Hampshire Water Transfer & Water Recycling Project Environmental Statement - Appendix 11.1 Response to Havant Borough Council Environmental Control Officer

Response to Havant Borough Council Environmental Control Officer

710166-SWS-XX-XX-CO-GE-00001 P01

A1 – Conceptual Site Model

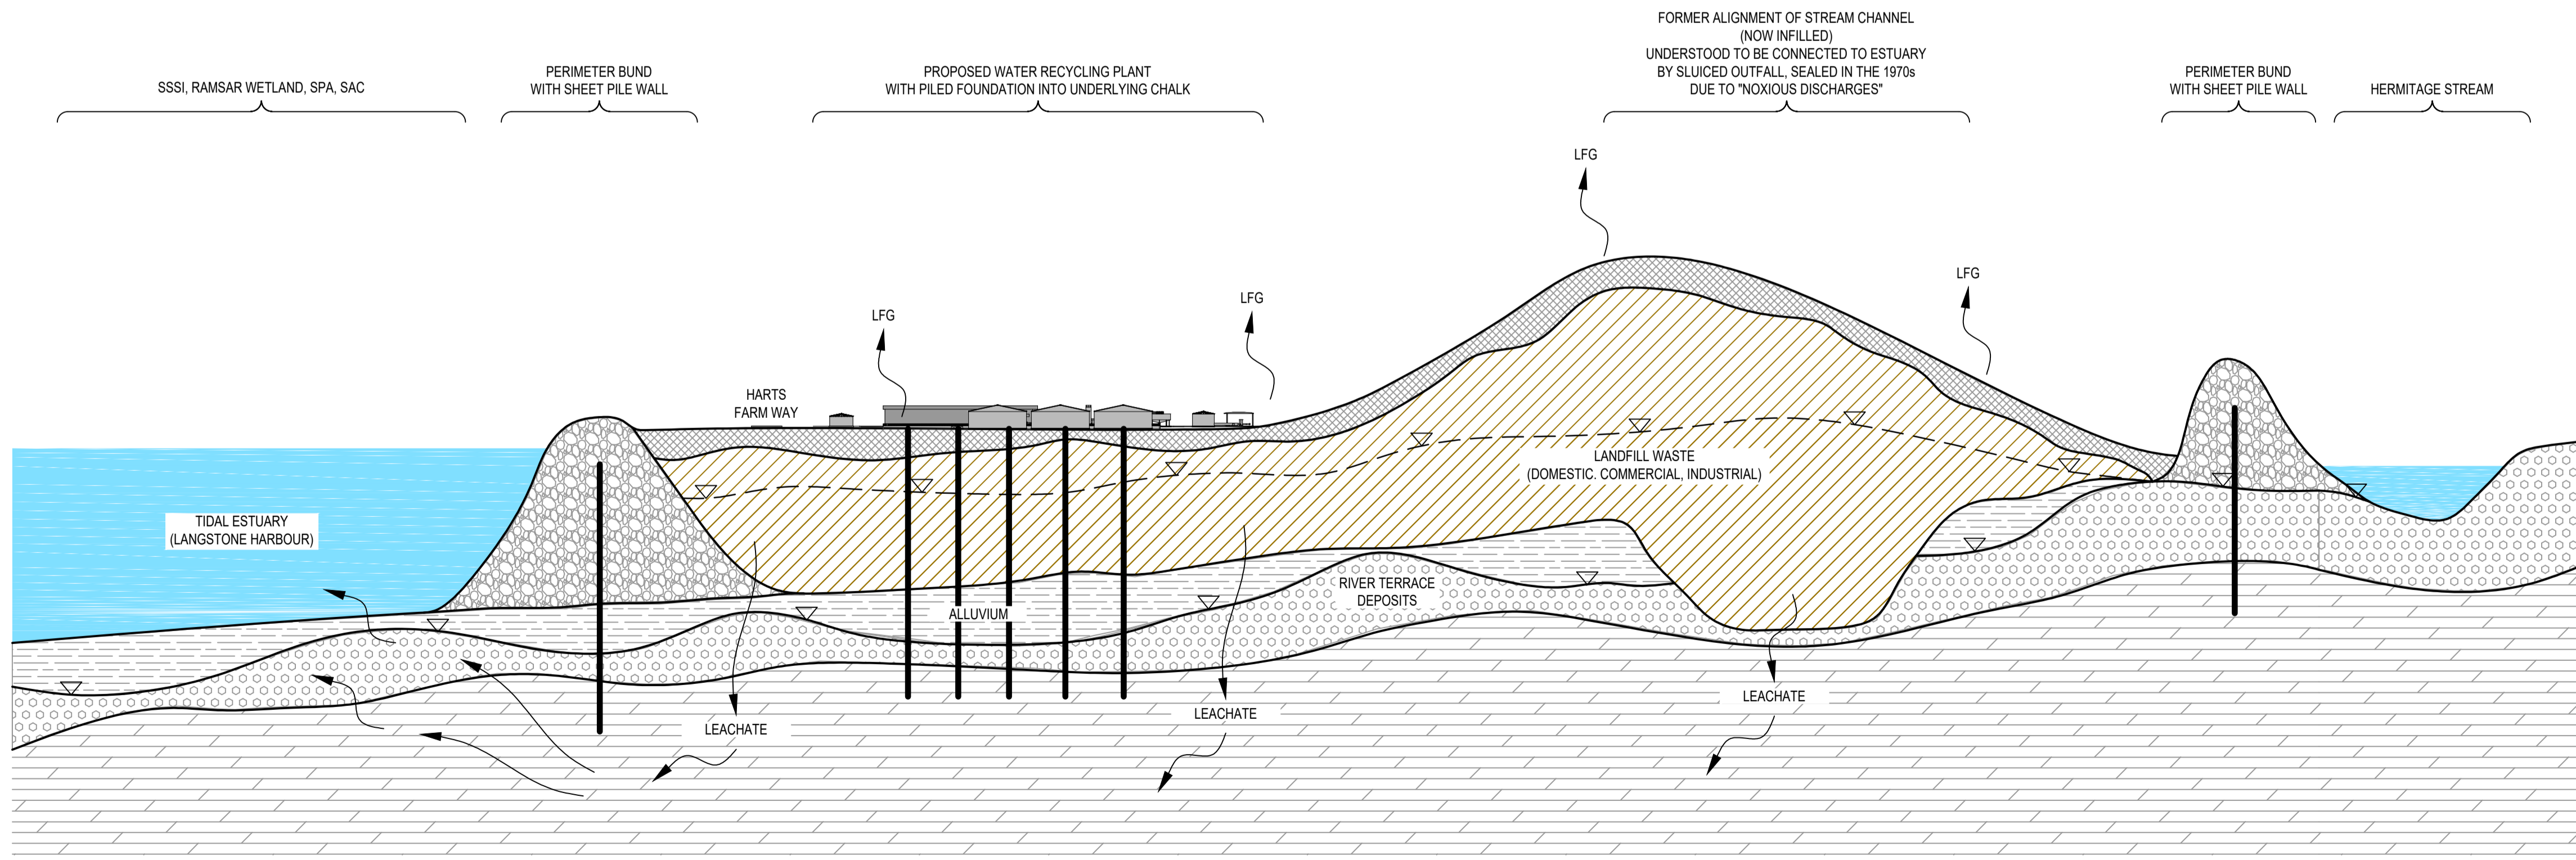
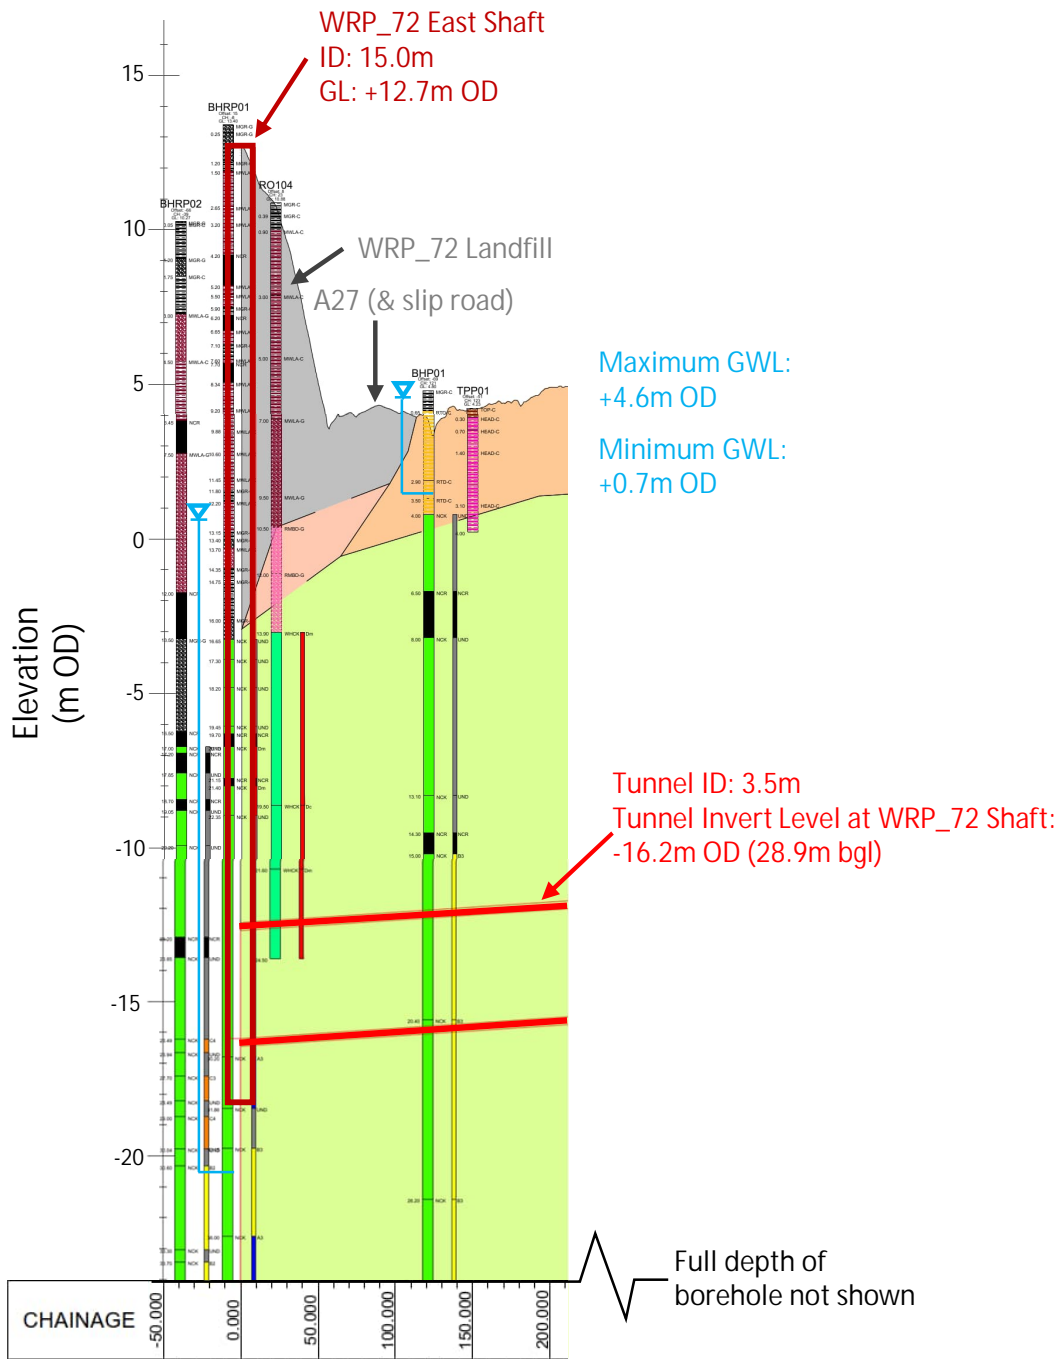
- 7.1. **ECO comment:** "... I suspect that the report has a broad scope and likely covers the entire pipeline route, however to my mind (from HBC's perspective-), the principle focus at this stage should be the interaction between the geo-environmental investigation/assessment and the Pipeline & WRP design details; I would like to maintain a fairly tight focus on the Broadmarsh site at this stage. Risks arising in the vicinity of the pipeline route are likely to be routine and easily managed, or to be associated with the landfill source".

- 7.2. **SW Response:** As detailed in paragraph 1.3, the GIR (SSP, 2023, Geo-Environmental Interpretative Report, ref: 331101000-RP-GEO-100.00948-710060-002 Version 2) covers the proposed WRP site. A conceptual site model (CSM) for the proposed WRP site is presented in Appendix A.

A1 – Shaft and Tunnel Sections

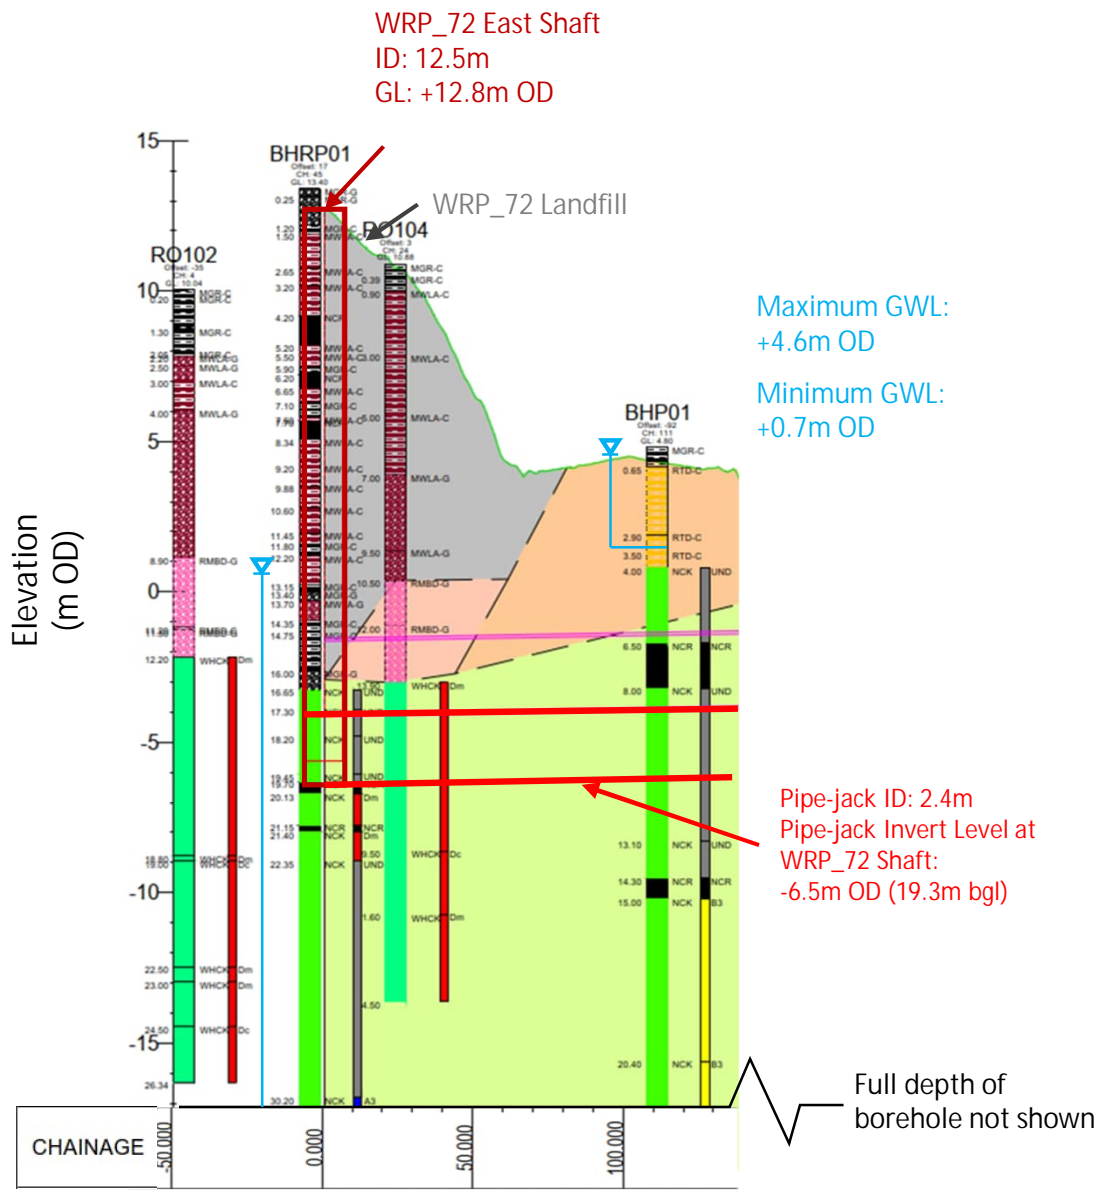
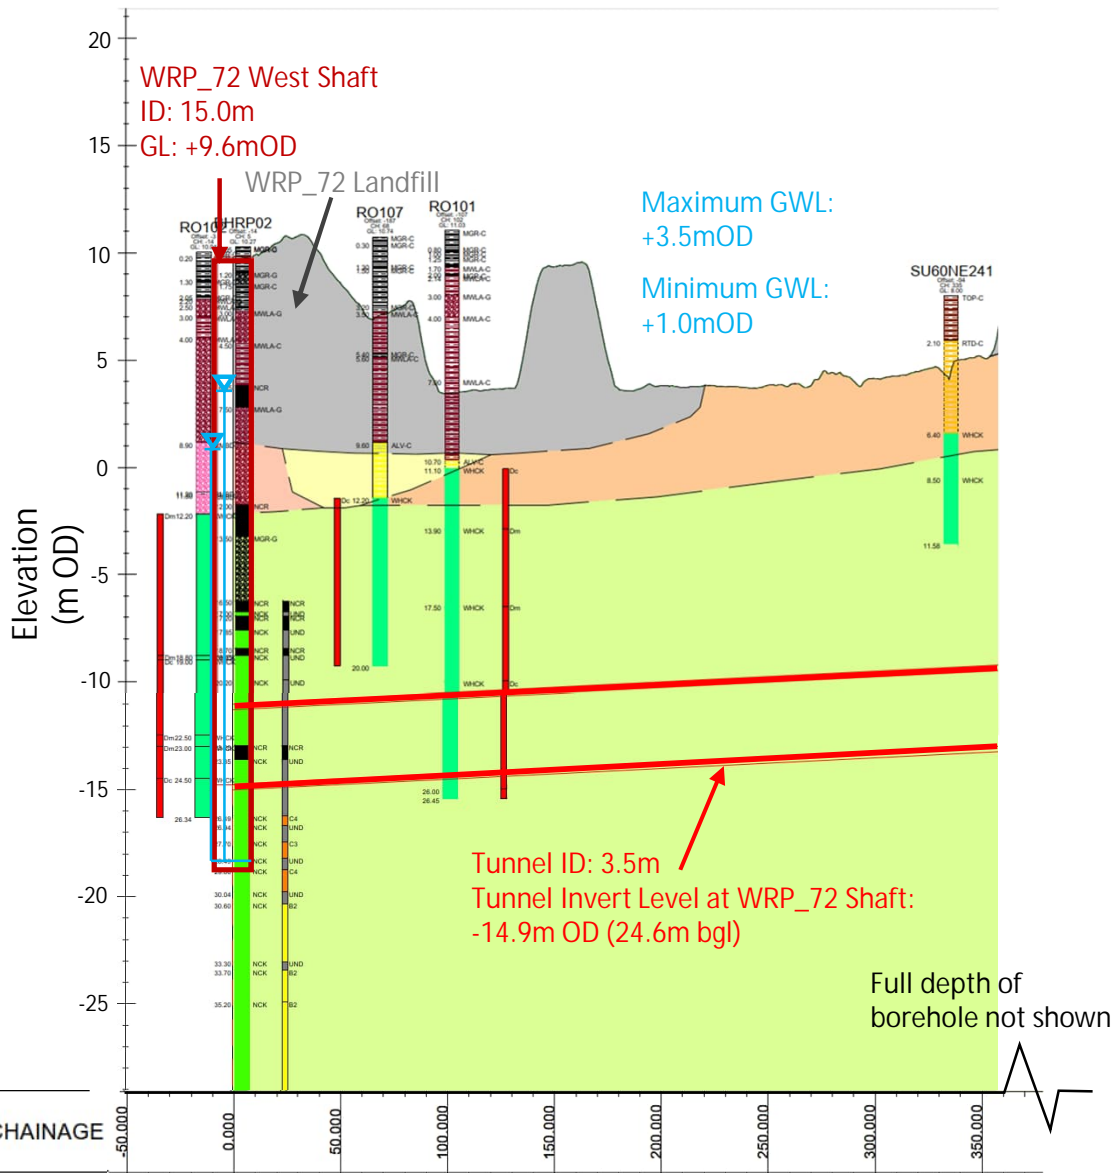
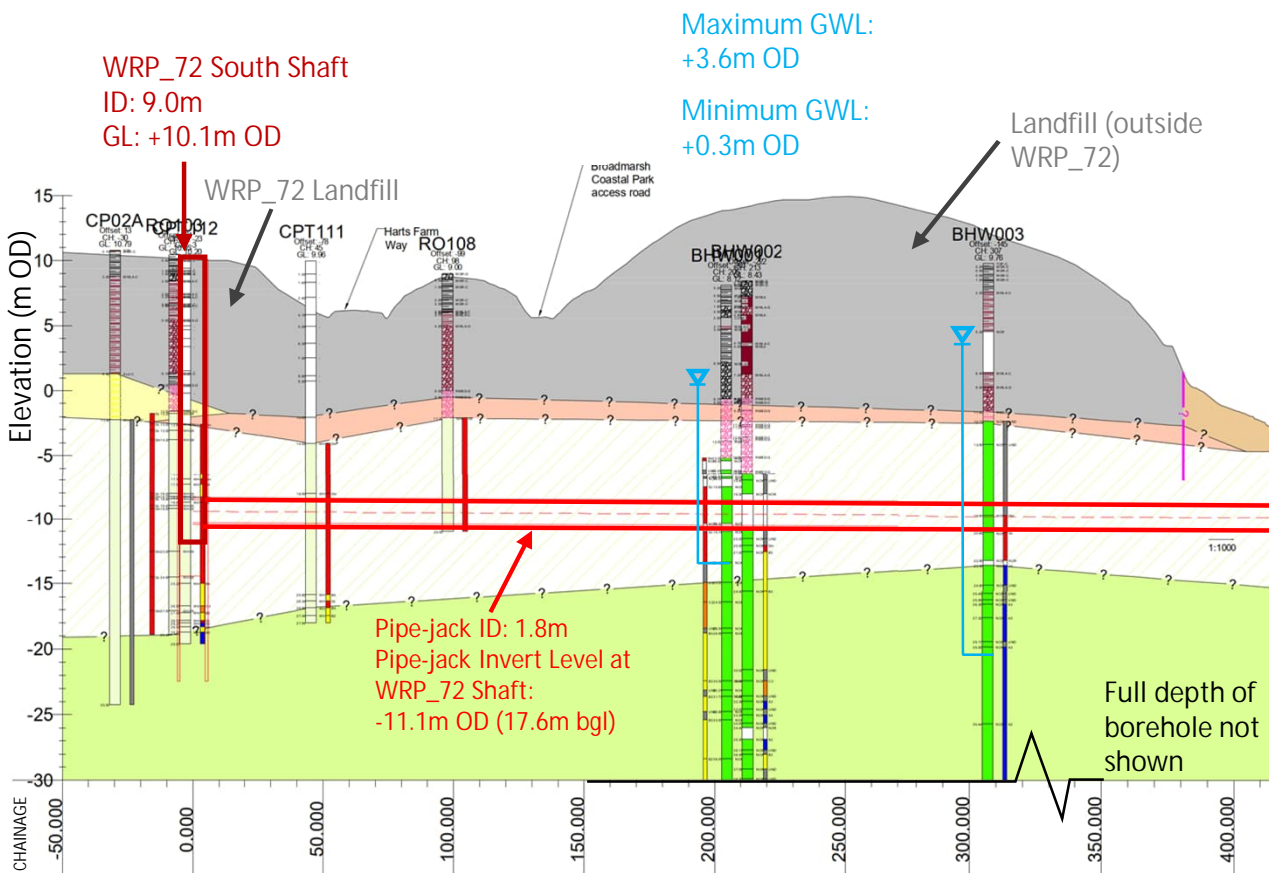
- 7.3. **ECO comment:** "it would also be helpful if you could outline some of the technical details relating to the pipeline specification, the absolute design constraints, installation process details (especially depth, jointing, precautions against settlement, and grouting-), and the requirements for- and general construction details of- any below ground voids associated with WRP (alongside any related design precautions)".

- 7.4. **SW Response:** The current design and construction details of proposed WRP foundations and underground shafts and pipelines are presented in Appendix B, this includes the current proposed depths and dimensions, possible construction methods (e.g. diaphragm walling, pipe jacking etc.) as well as relevant performance and technical requirements. Appendix C then specifically addresses each environment/health risk and concern highlighted by the ECO to date, by suggesting how the design and construction of each design element could mitigate them. It should be noted that the design of the proposed WRP foundations and underground shafts and pipelines presented in Appendix B is for outline design / planning stage only.

Proposed Development Components	General Description of Proposed Development Components ^[2]	Proposed Construction Method ^[2]	Relevant Performance and Technical Requirements ^[2]
Shafts	WRP to HTR Shaft^[1] 'WRP_72 East Shaft' (See Appendix A2, Figure 1) Purpose: TBM launch and accommodates pipeline between tunnel and WRP	The proposed arrangements of the shafts are shown in Appendix A2 (Figure 1 and Figure 3). The shafts located on the WRP_72 site will be constructed through the Landfill / Made Ground and other superficial deposits and will be founded below the landfill. Shaft for TBM launch or pipe jacking to comprise: Shaft cover slab: precast concrete.	<ol style="list-style-type: none"> 1) Working platform prepared at ground surface. 2) Deep soil mixing to stabilise the Landfill either side of the diaphragm wall to ensure excavation stability. 3) Excavate diaphragm wall panels to depth below shaft excavation level, install reinforcement and pour concrete. Then construct concrete capping beam. 5) Dewatering: Dewatering/depressurisation of groundwater within the diaphragm walling using dewatering wells within the shaft lining to allow excavation of the shaft in the dry. Preceded by fissure grouting of Chalk below base slab formation level (if needed) to provide further restriction of groundwater inflow. 6) Excavation within the shaft carried out to base slab formation level, then cast base slab. 7) Portal around tunnel eye opening to be constructed and secondary shaft lining to be cast. 8) Following tunnel construction, the portal opening and chamber for the pipe will be installed. 9) Mass concrete infill from the top of the base slab up to tunnel invert levels. 10) Construction of shaft cover slab. 	Design life: shafts shall be designed to 100 years in accordance with CED 4002 Issue No.10 Cl. 3.5 "Design Life". Pressure: All shafts designed to withstand water mains within the shafts, earth pressures and groundwater pressures during design life. Water tightness: shafts shall be designed to be 'substantially watertight' with no water flow penetrating the primary or secondary lining, per CESWI Cl. 11.11. Concrete: durability and tolerances must meet BS 8500-1:2015, CED4023 Issue No.4, Cl.4.25, and BS-EN 13670 requirements. Concrete mix to be appropriately designed for the aggressivity class of the Landfill / Made Ground and natural strata.

WRP to BHS Shaft^[1] 'WRP_72 East Shaft' (See Appendix A2, Figure 2) Purpose: Pipe jacking launch and accommodates pipeline between tunnel and WRP	Diaphragm wall (primary lining): reinforced diaphragm wall with overlapping panels. Diaphragm wall to be cut/removed as required for the construction of tunnel portal. Diaphragm walls extend below shaft excavation level to provide cut-off and reduce inflow of water into shaft during excavation. Secondary lining: cast in situ reinforced concrete lining within the diaphragm wall for watertightness. Tunnel-to-Shaft portal: reinforced concrete portal integrated into the secondary lining. Base slab: cast in situ circular reinforced concrete slab.		
	WRP to Purbrook Shaft 'WRP_72 West Shaft' (See Appendix A2, Figure 3) Purpose: TBM launch and accommodates pipeline between tunnel and WRP	Mass concrete infill: to raise the shaft invert levels above the base slab to the required finished level. Sump: integrated into the mass concrete infill.

WRP to Budds Farm Shaft 'WRP_72 South Shaft' (See Appendix A2, Figure 4) Purpose: Pipe jacking launch and accommodates pipeline between tunnel and WRP			
TBM Tunnels	WRP to HTR Tunnel^[1] 'Havant Thicket Route' (See Appendix A2, Figure 1) Purpose: Accommodates pipelines between WRP and HTR	The proposed arrangements for the tunnels are shown in Appendix A2 (Figure 1 and Figure 3). The tunnels will be constructed below the Landfill / Made Ground and other superficial deposits, through natural strata. Tunnel to be constructed using Earth Pressure Balance (EPB) TBM or Slurry TBM. EPB TBM utilises a pressurised plug to counteract the external earth and hydrostatic pressures, advantage is limiting mobilisation of Chalk 'flour' from TBM operation. Slurry TBM utilises a compressed air cushion / bubble to fine tune the slurry support pressure, advantage is better resilience against flint wear and reduced need of intervention for maintenance.	<ol style="list-style-type: none"> 1) TBM assembled within launch shaft. 2) TBM excavates the tunnel using its rotating cutter head to break through the soil/ rock. 3) Spoil management: EPB TBM: spoil to be transported from cutting face through a screw conveyor and guillotine valve for onward transfer out of tunnel by conveyor/wagons. Slurry TBM: slurry of excavated material, water and drilling fluids transported through discharge pipe to treatment plant at surface for segregation. Cleaned slurry returned to TBM vial slurry feed pipe. 4) Pre-cast concrete segments transported into tunnel and assembled to form complete rings with grouting behind the tunnel lining to create seal between the soil and segments. 5) TBM advances with excavation, spoil removal and construction of tunnel lining in a cyclical process and constant monitoring/ adjustments to ensure alignment and face pressure. 6) TBM breakthrough at reception shaft followed by disassembly. 7) Installation of water pipeline(s) into tunnel. 	Design life: tunnels shall be designed to 100 years in accordance with CED 4002 Issue No.10 Cl. 3.5 "Design Life". Pressure: All tunnels designed to withstand water mains within the tunnels, earth pressures and groundwater pressures during design life. Water tightness: tunnels shall be designed to be 'substantially watertight' with no water flow penetrating the primary or secondary lining, per CESWI Cl. 11.11. Concrete: durability and tolerances must meet BS 8500-1:2015, CED4023 Issue No.4, Cl.4.25, and BS-EN 13670 requirements. Concrete mix to be appropriately designed for the aggressivity class of the Landfill / Made Ground and natural strata.

WRP to Purbrook Tunnel 'Purbrook Route' (See Appendix A2, Figure 3) Purpose: Accommodates pipeline between WRP and Purbrook	Tunnel lining to comprise: Pre-cast concrete segments typically 1m length incorporating elastomeric gaskets to provide a watertight connection. Tail-skin grouting to provide grouted annulus around tunnel lining and prevents creation of preferential flow path along tunnel during construction and in the permanent case.		
Pipe Jack Tunnels	WRP to BHS Pipe Jack^[1] 'Bedhampton Springs Route' (See Appendix A2, Figure 2) Purpose: Accommodates pipelines between WRP and BHS	The proposed arrangements for the pipe-jack tunnels are shown in Appendix A2 (Figure 2 and Figure 4). The pipe-jack tunnels will be constructed below the Landfill. Tunnel for water pipelines to be constructed by pipe jacking. The pipe jacking method is a widely used trenchless technique for installing small-diameter utility tunnels by hydraulically pushing a series of jacking pipes behind a tunnelling shield undertaking a controlled excavation at the advancing face. The tunnelling shield and jacking pipes are pushed/jacked from a launch shaft to a reception shaft.	<ol style="list-style-type: none"> 1) Jacking frame installed at the base of the launch shaft. 2) Pre-cast concrete jacking pipe is positioned in the launch shaft. 3) Mechanical excavation tool (likely to be EPB or Slurry TBM) to break through the soil/ rock in front of jacking pipe and excavated soil removed from the pipe using conveyor belts/slurry pipeline. 4) Hydraulic jacks used to push pipe forward into the soil. 5) As each pipe is pushed forward, the next pipe is added and jacked into place, continuing the process until the pipes reach the reception shaft. 6) Bentonite pumped into annulus to reduce friction while pipe jacking. 7) Annulus grouting upon completion of pipe jacked tunnel to fill any voids and stabilise the tunnel. 8) Installation of water pipeline(s) into tunnel.

WRP to Budds Farm Pipe Jack 'Budds Farm Route' (See Appendix A2, Figure 4) Purpose: Accommodates pipelines between WRP and Budds Farm WTW	Tunnel lining to comprise: Pre-cast concrete jacking pipes typically 2-2.5m length with joints incorporating elastomeric gaskets to provide a watertight connection. A low permeability lubricant (for example, bentonite) can be injected into the annulus around the jacking pipes during installation to aid advancement of the pipe jack and prevent the formation of a preferential flow path around the pipe during installation. Grouting at the end of pipe jacking around the pipe annulus can be applied to prevent creation of preferential flow path along tunnel in the permanent case.		
Other Permanent Structures Foundations	Proposed WRP Foundations (See Appendix A1 for indicative WRP development) Purpose: To support structures associated with the proposed WRP. Structures e.g. tanks, pumping station, storage and prep areas, silos, office facilities etc.	Deep foundations i.e., piles are assumed to be required to transmit loads below the Landfill / Made Ground for all permanent structures due to potential non-uniform surface settlements. CFA method is preferred for pile construction, other methods may be used such as bored piling.	CFA option is preferred for outline design stage but method is subject to further assessment. Pile length to be confirmed after detailed assessment. Other methods may be used such as bored piling. <ol style="list-style-type: none"> 1) CFA rig positioned over designated pile location. 2) Continuous flight auger drilled into the ground to required depth (extending beyond Landfill). 3) Once the required depth is reached, concrete is pumped through the hollow stem of the auger as the auger is withdrawn along with excavated material carried to the surface by the auger flights. 4) After the auger is fully withdrawn, a reinforcement cage is inserted into the fresh concrete. The cage is typically pre-fabricated and is lowered into the pile using a crane or other lifting equipment. 5) Concrete to cure and gain strength for pile to achieve its designed load-bearing capacity. 	Design life: Foundations shall have a design life commensurate with the design life of the structure they support. Loading and displacement: Foundations will be designed to support the required loads at tolerable displacements in accordance with BS EN 1997-1 and BS 8004. Where relevant, this will include resisting downdrag actions from negative skin friction due to ongoing displacement / settlement of landfill. Concrete: Concrete mix to be appropriately designed for the aggressivity class of the Landfill / Made Ground and natural strata.
